Chapter 6

Items 6-1-12 through 6-70-12

June 14, 2013.

**Ballot Comment and Proponent Comment Agenda- July 15-19, 2013:
Proposals of 2012 submitted on the ICC A117.1-2009**

6-5– 12 604.4, Figure 604.4

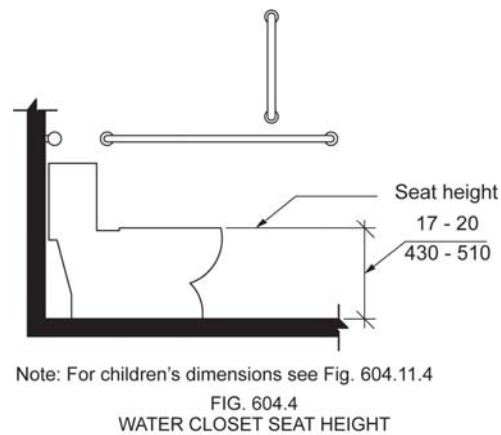
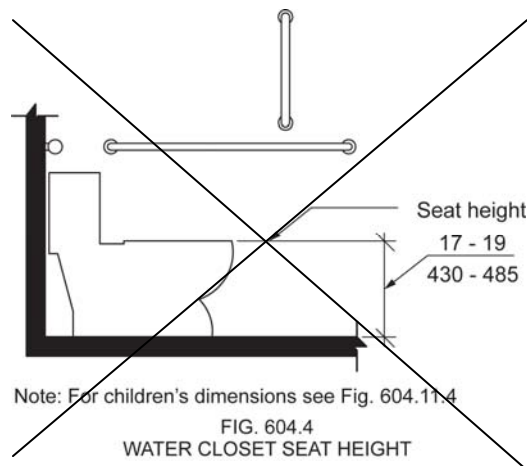
NOTE: This change necessitates a change to Fig. 604.4 to ensure consistency. Thus, the proposed revised figure has been attached, along with the existing figure for comparison purposes.

Comment: The research results clearly shows that a higher range would be beneficial for wheeled mobility users but allowing fixed heights as high as 25 in. could cause difficulty for people who need low seat heights, as the committee noted in defeating the original proposal. I didn't think about an amendment when we voted on the proposal but only exception #1 was changed it would allow a range from 11-25 in. for adjustable water closets. This would mean that, as adjustable products come on the US market, they would provide a great alternative to the fixed seat height that would be too low for many people yet not disadvantage people of short stature or children with disabilities. At the July meeting, I will offer this proposal.

6-15- 12
604.7, Figure 604.7

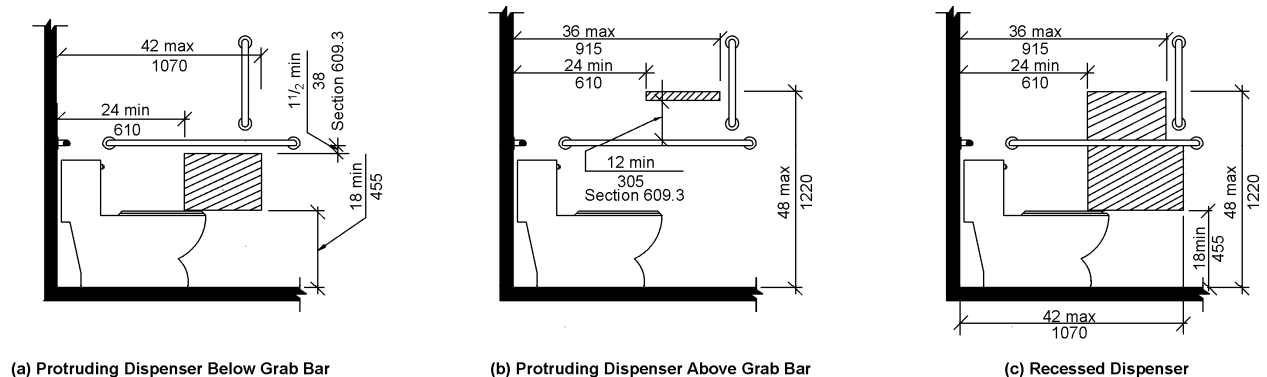
Change the vertical dimension on figures (a) and (c) indicating the vertical placement of dispensers above the floor from : ~~48 min (455)~~ to 15 min (380).

1. Inconsistent with ICC A117.1- 2009
 Section 3098.2 Forward Reach, 308.2.1 Unobstructed (Page 11), " low forward reach shall be 15 inches (380 mm) minimum"
 Figure 308.2.1 Unobstructed Forward Reach (Page 11), dimension call out "15 min (380 mm)"
 Section 308.3 Side Reach, 308.3.1 Unobstructed (Page 13, " low side reach shall be 15 min (380 mm)"

2. Inconsistent with 2010 ADA Standards
 Section 604.7 Dispensers (page 201), "the outlet of the dispenser shall be 15 inches (380 mm) minimum"
 Figure 604.7 Dispenser Outlet Location (page 202), dimension call out "15 min (380 mm)"

Comment: For consistency the ADA should harmonize with preferred, approved Proposal 6-14-12, "The outlet of the dispenser shall be 14 inches minimum and 19 inches maximum above the floor."

Table 604.9.3.1, Figure 604.9.3.1

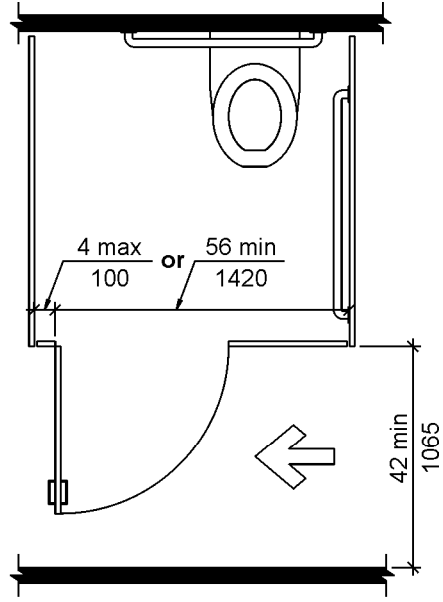
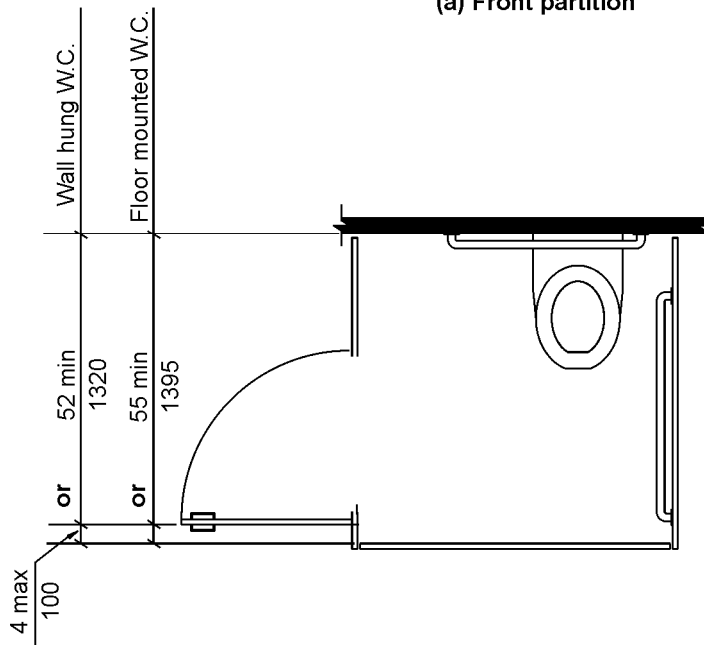
Change the called dimension for door opening location to read: 4 inches (100 mm) minimum to 6 inches (150mm) maximum).

Fig. 604.9.3.1
Wheelchair Accessible Compartment Doors

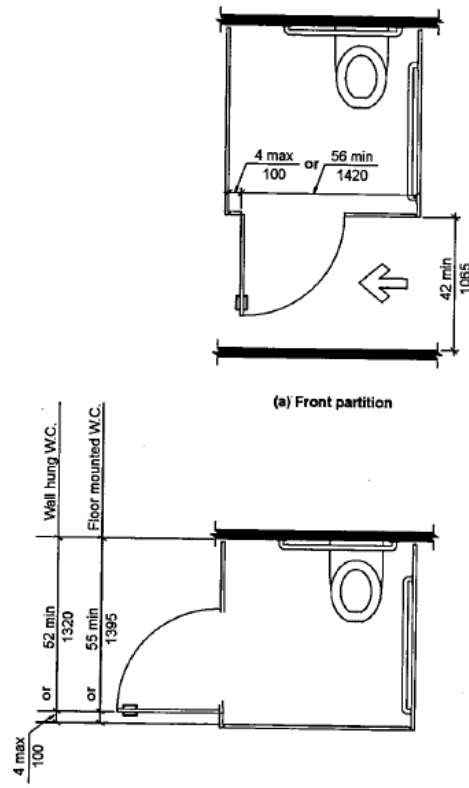
Change the called dimension for door opening location to read: 4 inches (100mm) minimum to 6 inches (150mm) maximum.

604.9.5, Figure 604.9.5, 609.5.1, 609.5.2

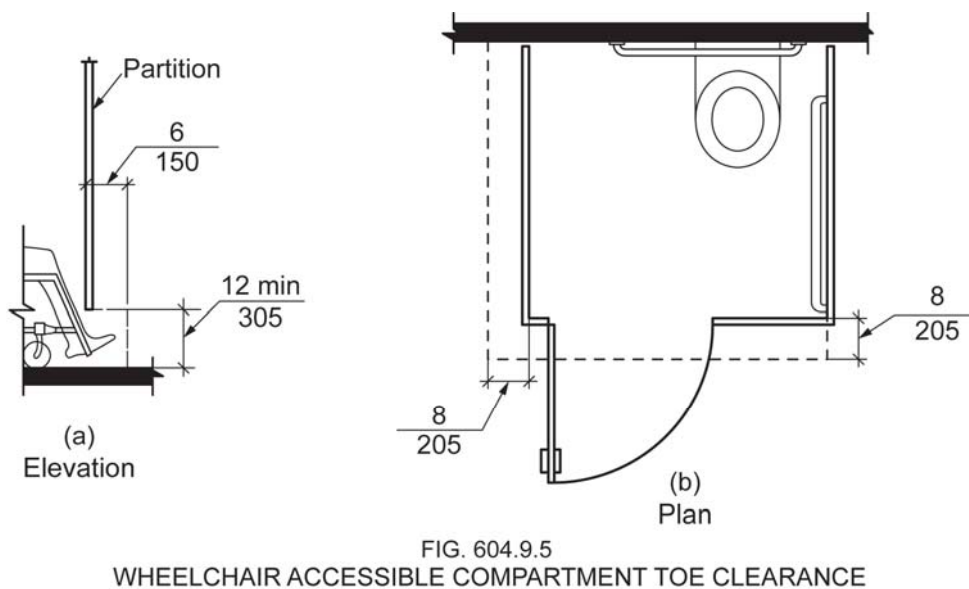
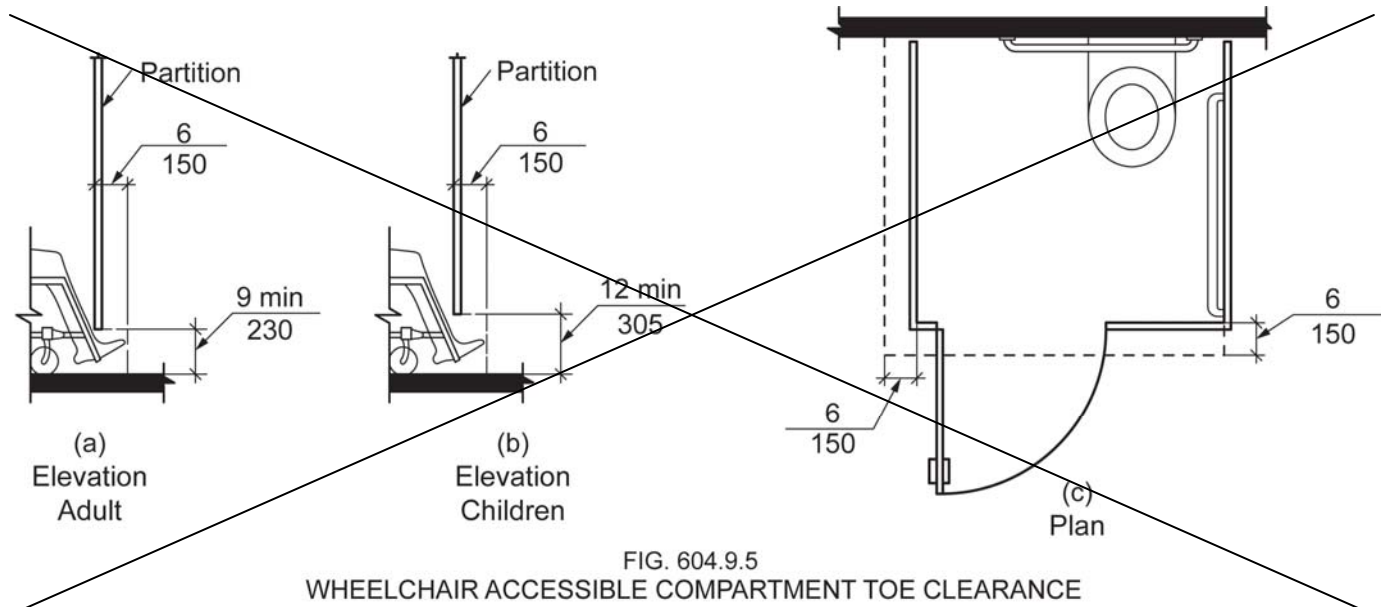
These figures assume the wheelchair occupant is as far forward to the partition as possible but it does not account for the total occupied length of the device. Based on the existing ANSI standard, we propose that the exceptions be changed accordingly to account for the additional 2 inches of space added for toe clearance. This means that if an adjacent compartment does not have the requisite 8 inches, the accessible compartment must have 2 more inches than previously required in order to be exempted. Further, Steinfeld, et al., 2010 (pg. 95, fig. 4-5) notes that in order to allow 95% of power and manual wheelchair users to perform a 180-degree turn, a 67-inch width is necessary, which is consistent with the proposed change to the exemptions.

NOTE: This change necessitates a change to Fig. 604.9.5 to ensure consistency. Thus, the proposed revised figure has been attached, along with the existing figure for comparison purposes.

606.3, Figure 606.3

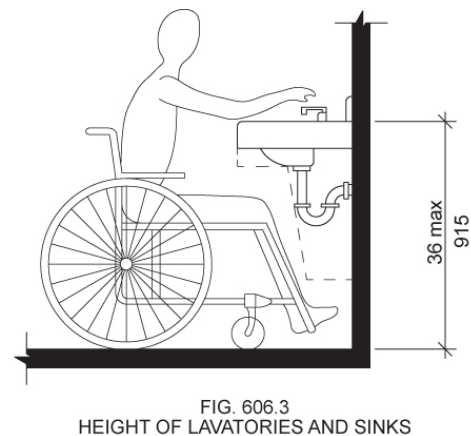
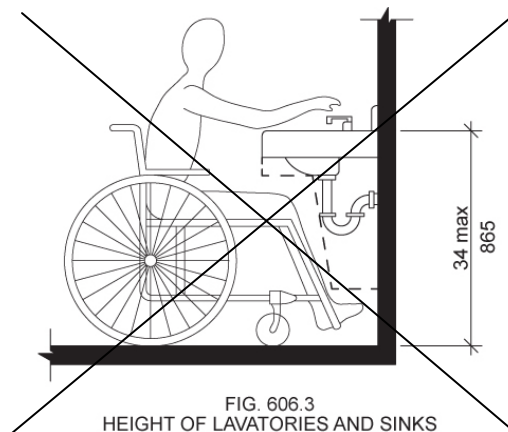
NOTE: This change necessitates a change to Fig. 606.3 to ensure consistency. Thus, the proposed revised figure has been attached, along with the existing figure for comparison purposes.

FIG. 607.2(b)
CLEARANCE FOR BATHTUBS

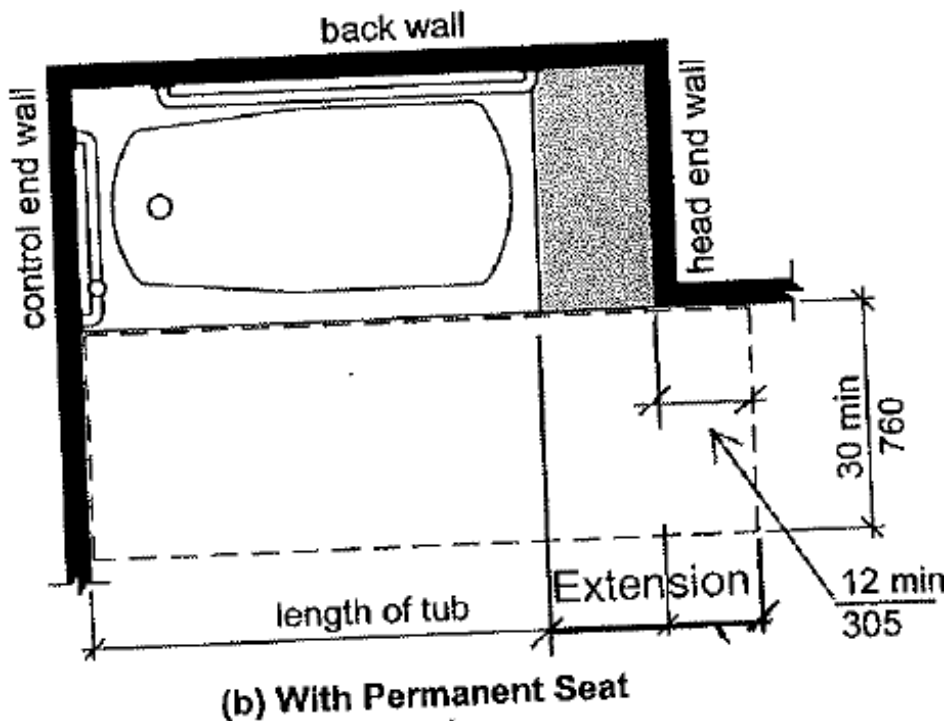
Section 607.4.1 sets the 'depth' of the seat. The current language skips the piece between the 'length of the tub' and the end of the extension. This is a technical issue that just gives you all the pieces. Please see graphic revision attached.

Comment: The language needs to match Figure 607.2(b). The current text has a gap between the end of the tub and the space past the end wall.

6-39.4

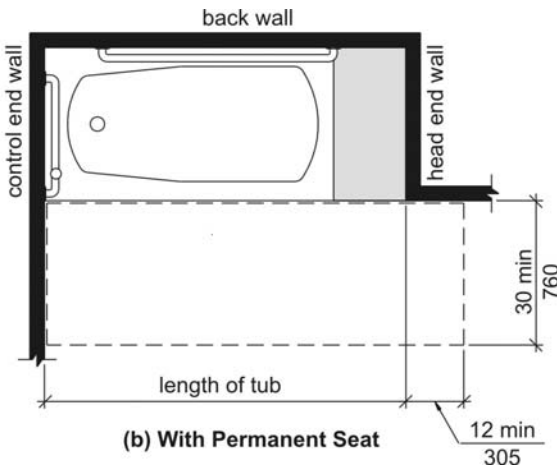
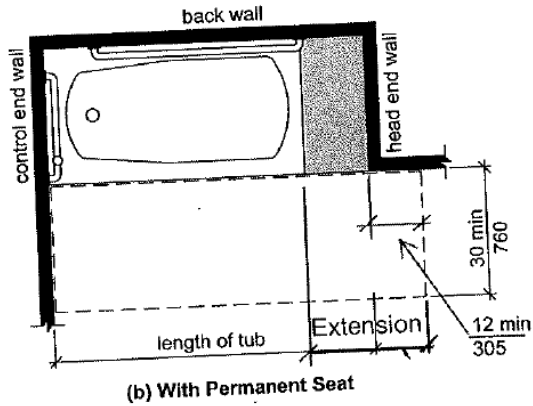
Comment: The permanent seat and extra 12" beyond needs better description.

Reason: The committee said the current language was clear, however, I sincerely believe they were looking at my corrected drawing, and not the existing Figure 607.2(b). See below. Definitely what is shown is not the length of the tub. If the language is clear, the drawing should be corrected – or both.

607.2 Transfer Clearance. A clearance in front of bathtubs extending the length of the bathtub and 30 inches minimum in depth shall be provided. Where a permanent seat is provided at the head end of the bathtub, the clearance shall extend 12 inches minimum beyond the wall at the head end of the bathtub.

610.2, Figure 610.2, 610.3

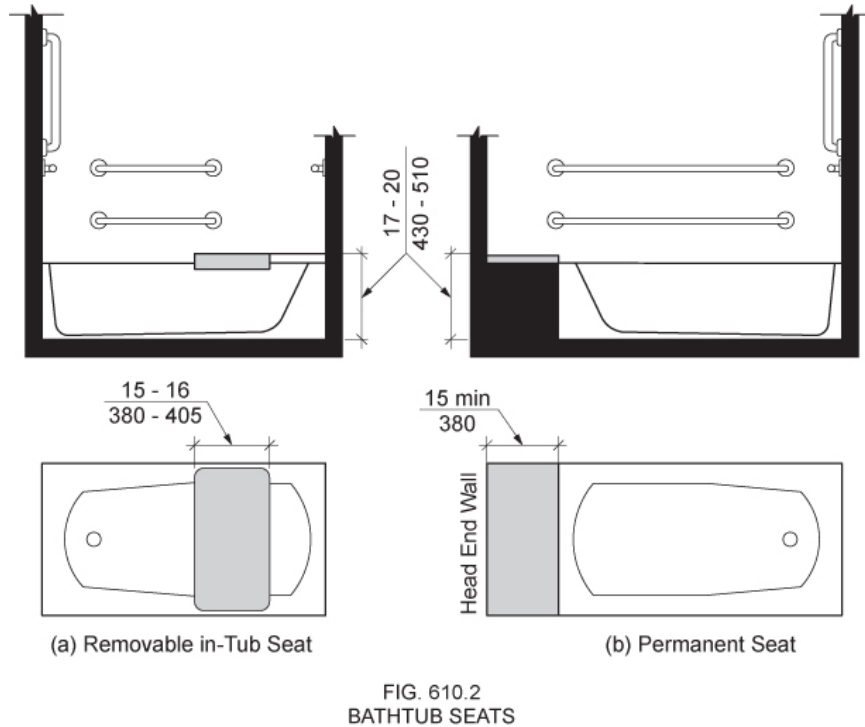
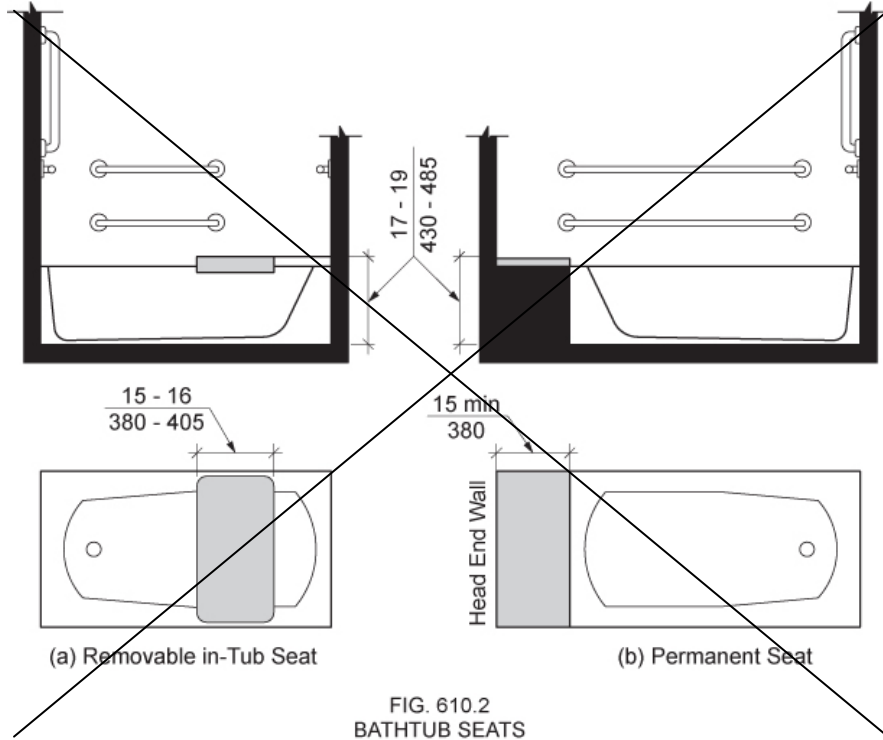
NOTE: This change necessitates a change to Fig. 610.2 to ensure consistency. Thus, the proposed revised figure has been attached, along with the existing figure for comparison purposes.
